Access Compliance Report

Public Rights-of-Way

(Curb Ramps)

Intersection ID: 5752	Main Street: DELLINGER_CR	Cross Street: MILHAVEN_LN	Location: NW
ADA ID: 89203C047F3E	Ramp Type: BlendTrans1	Initial Pass/Fail: Pass	Overall Compliance: No
		Severity Score: 2.5

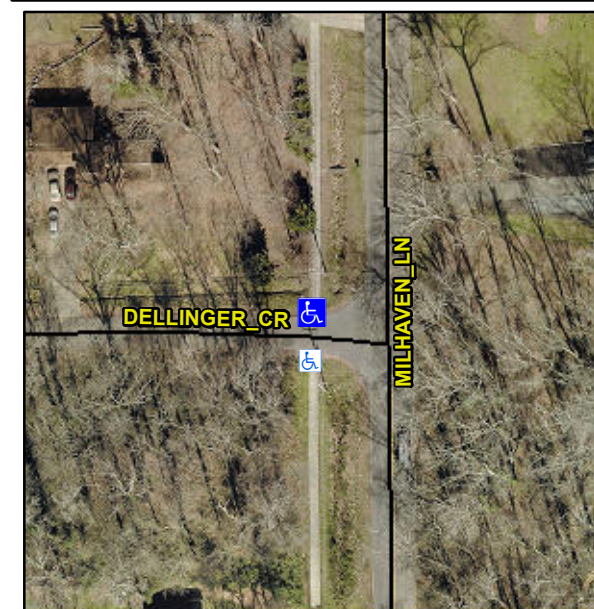
NO CURB, DWS OS TO ASPHALT

R304.2.2-Perp, R304.3.2-Para, R305.1.4, R305.2

Remove & Replace Curb Ramp With Two New Directional Ramps or Equivalent.
